**TOWN OF BAY HARBOR ISLANDS
PLANNING AND ZONING BOARD**

1. Request for approval for a new single family home for “1330 BH, LLC” located at 1330 98 Street, Lot 3 of Block 35. The owner is proposing to construct a new two story single family home. The proposed two story home has approximately 6,844 square feet of a/c living. The residence will have 5 bedrooms, 6 full baths and one half bathrooms. Enclosed please find the site plan and elevations. (Item #1)

1330 98TH ST, BAY HARBOR ISLANDS, FL 33154

Subject: Site Development Plan Application
Single-Family Residence
1330 98th Street
Bay Harbor Islands Acct. No.: 2020-XXX
MMPA Acct. No.: 01-0702-1097

Drawing: Landscape Plan

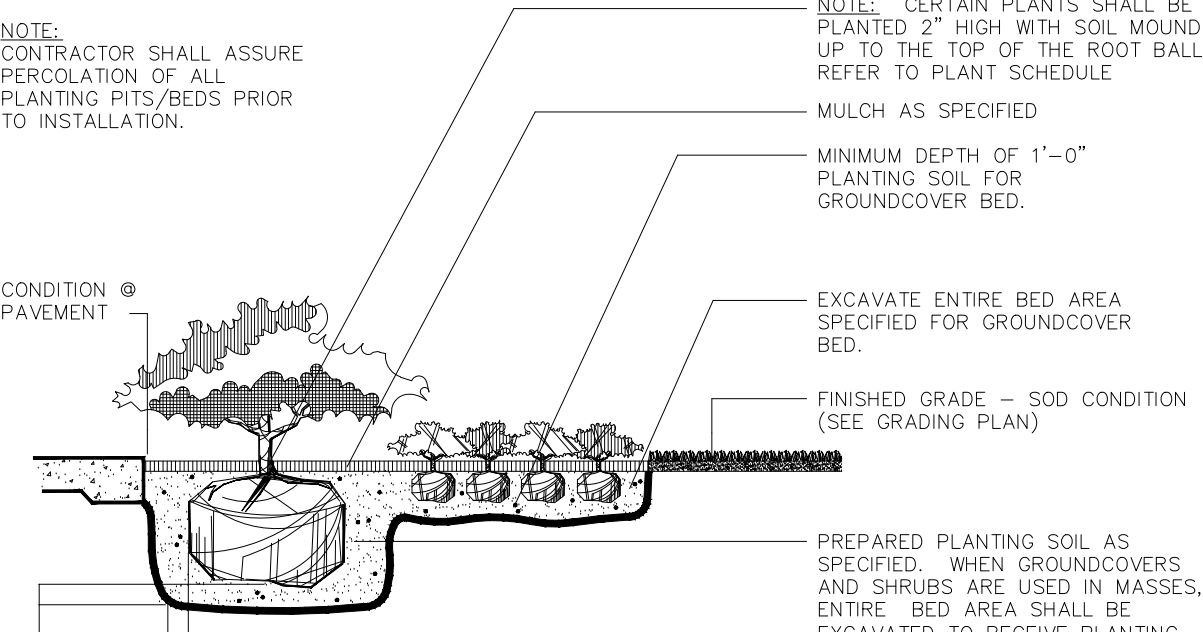
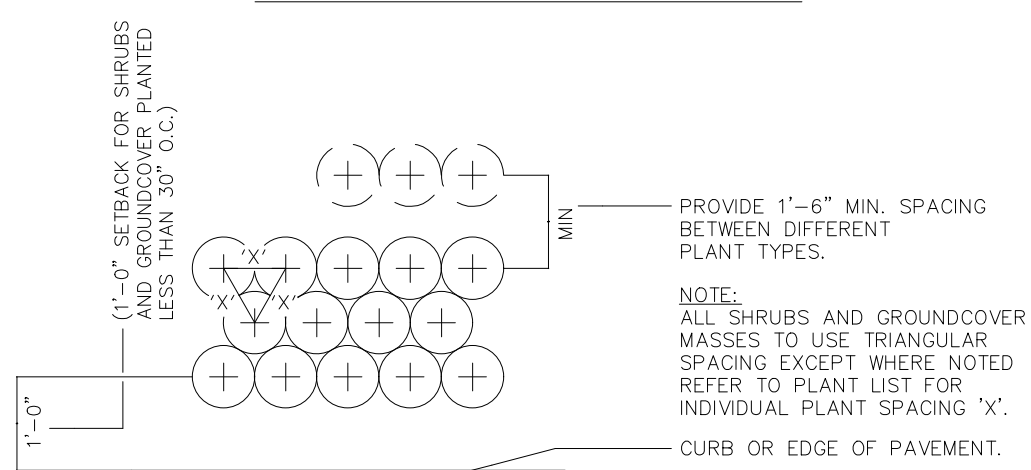
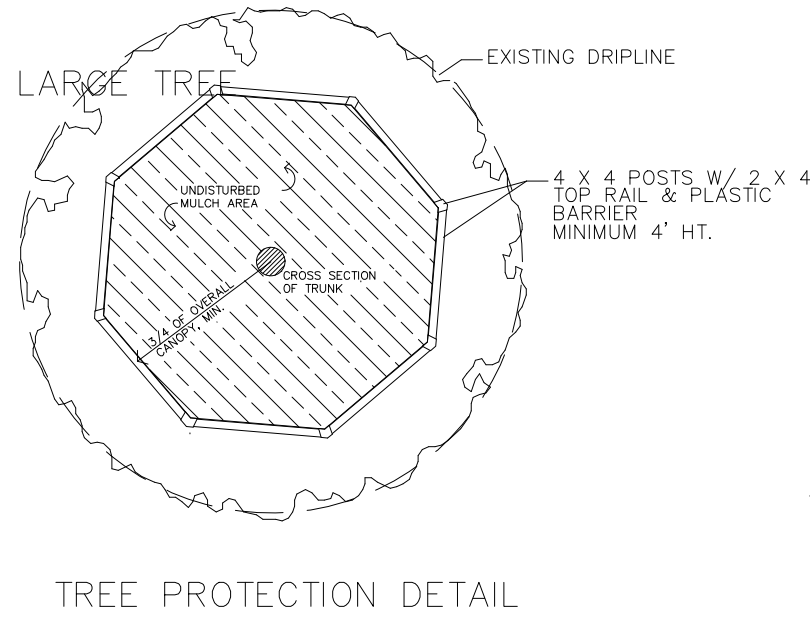
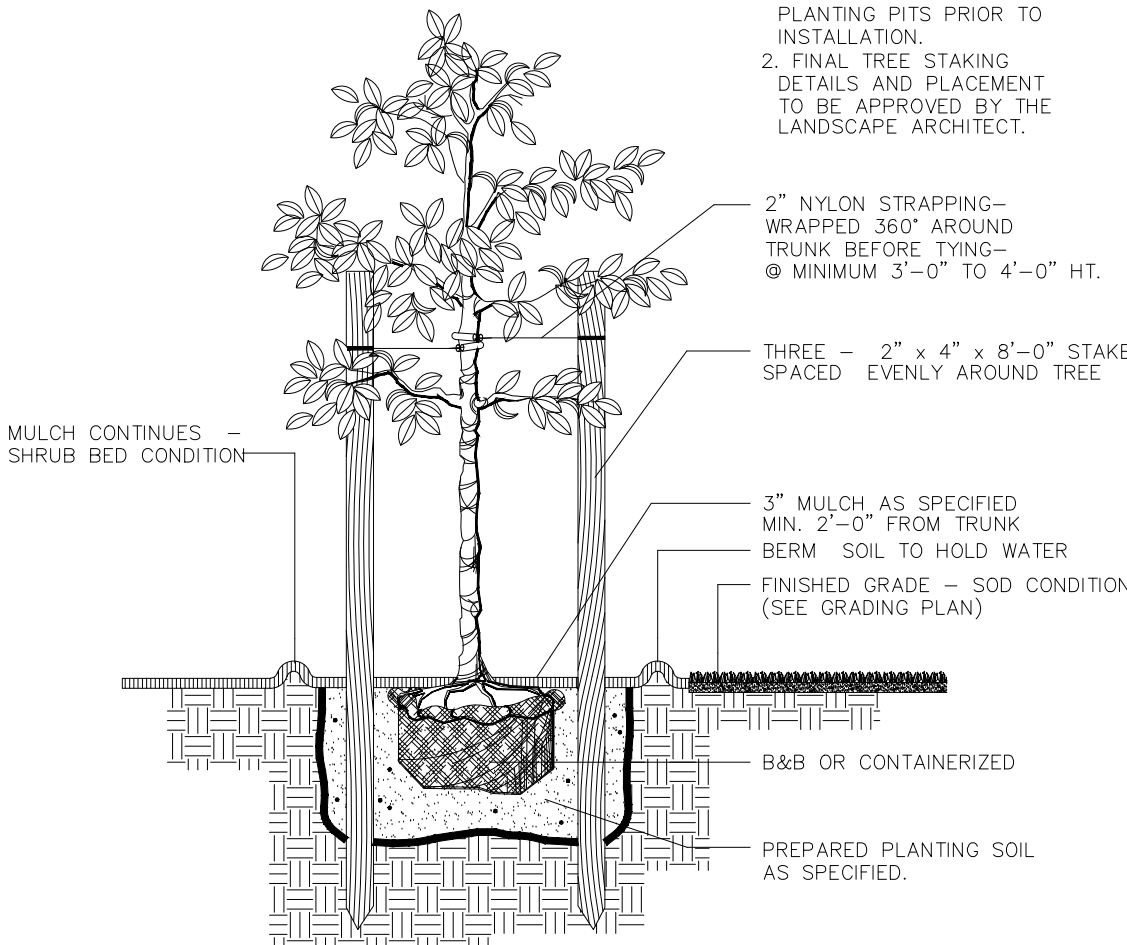
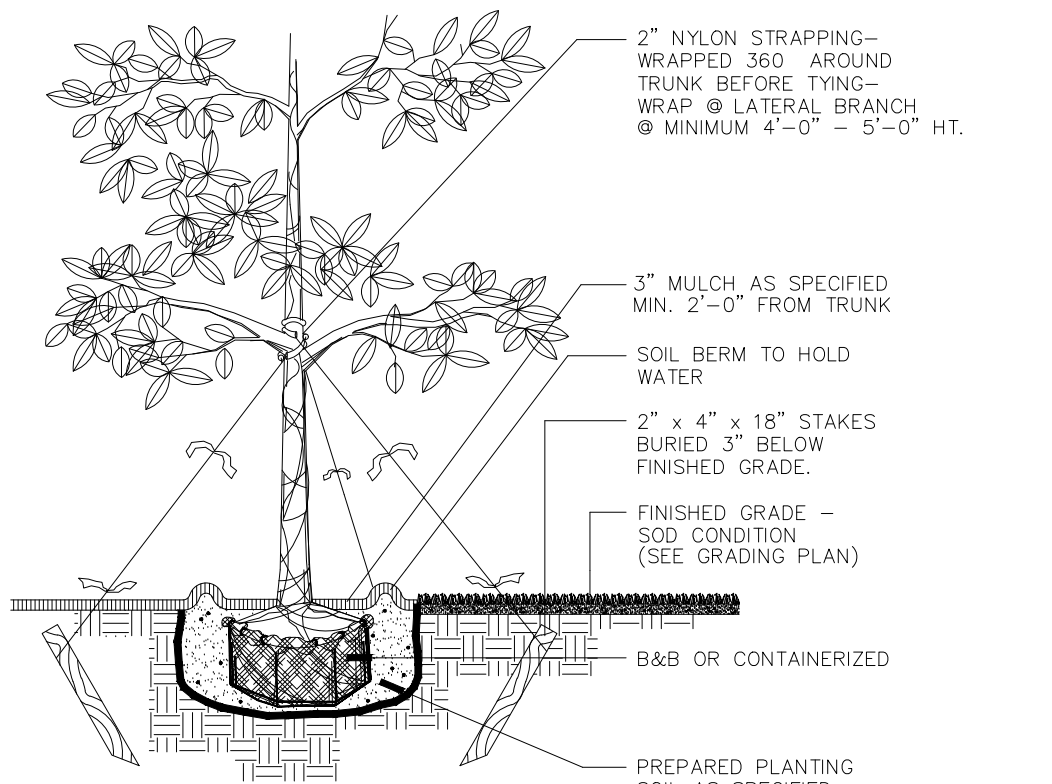
Revisions:
REV #1: Moved palm in back away from O.H. powerlines per city's comments.
Pool equip & A/C units screened w/ CG
Second driveway added

1330 RESIDENCE
Landscape Elevations

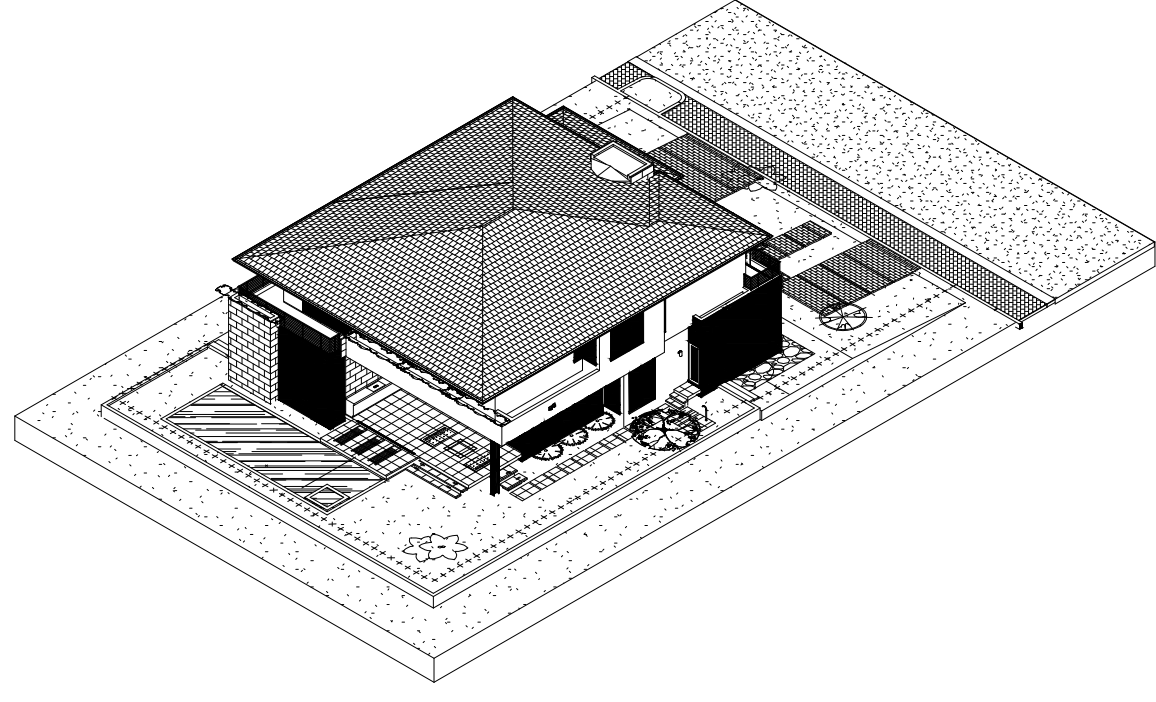
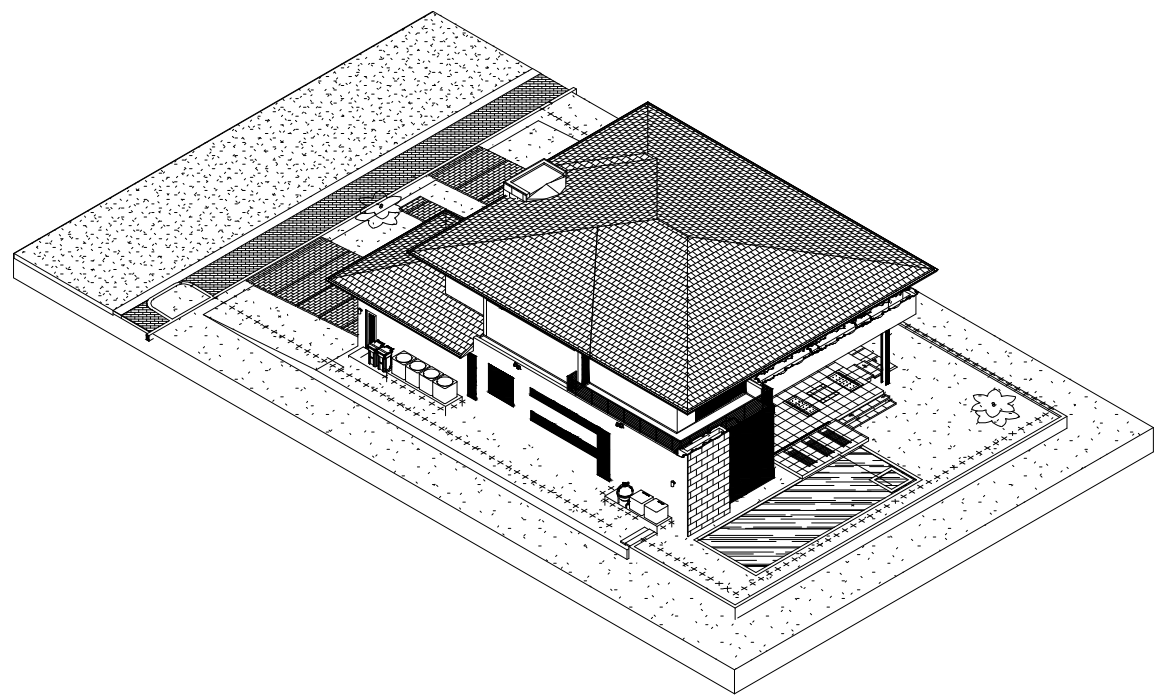
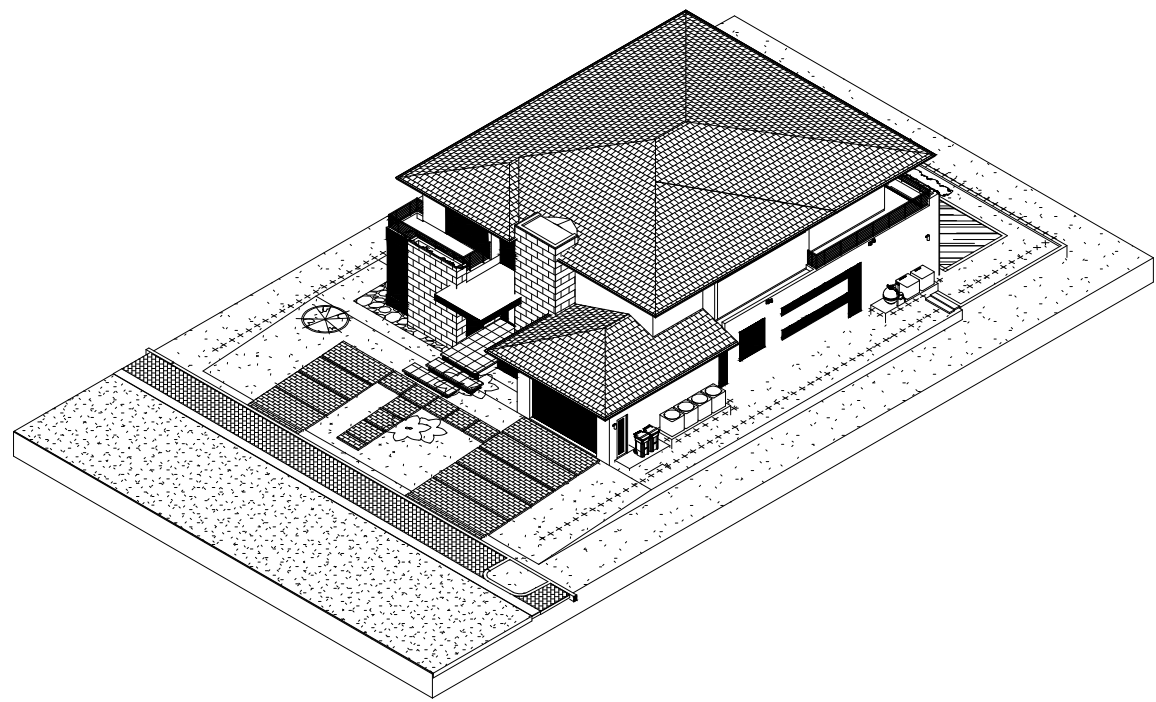
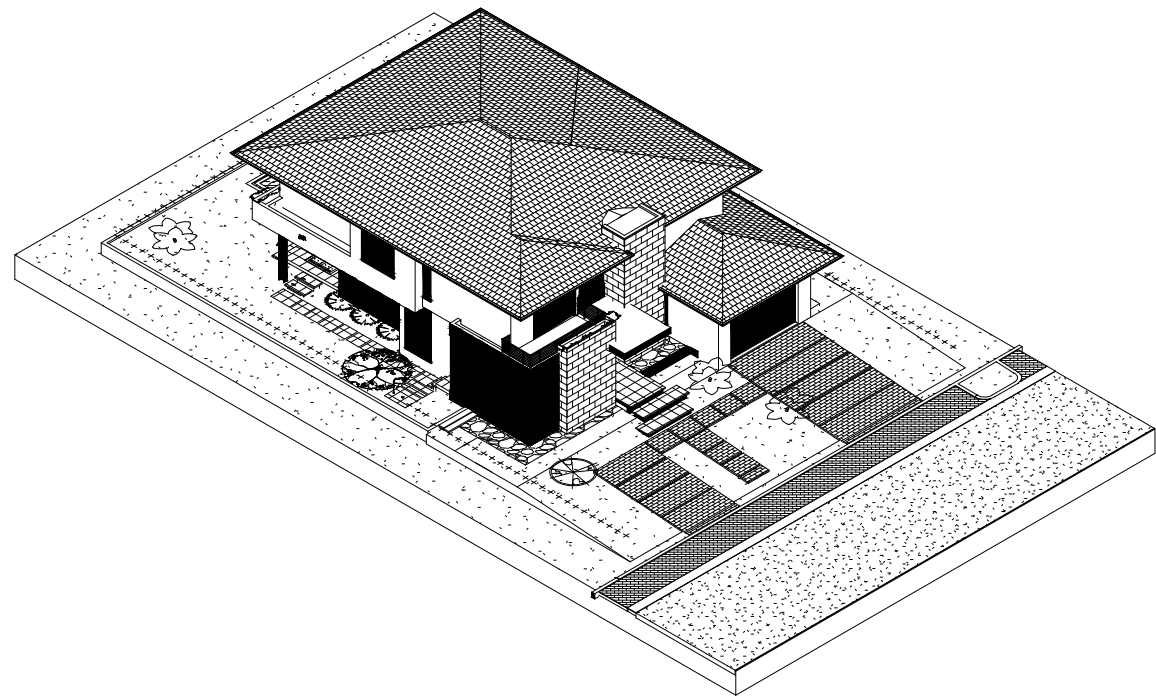
Revisions:
REV #1:
Added L-3 Sheet per city's comments
REV #2:
Secondary driveway added 10.14.2020
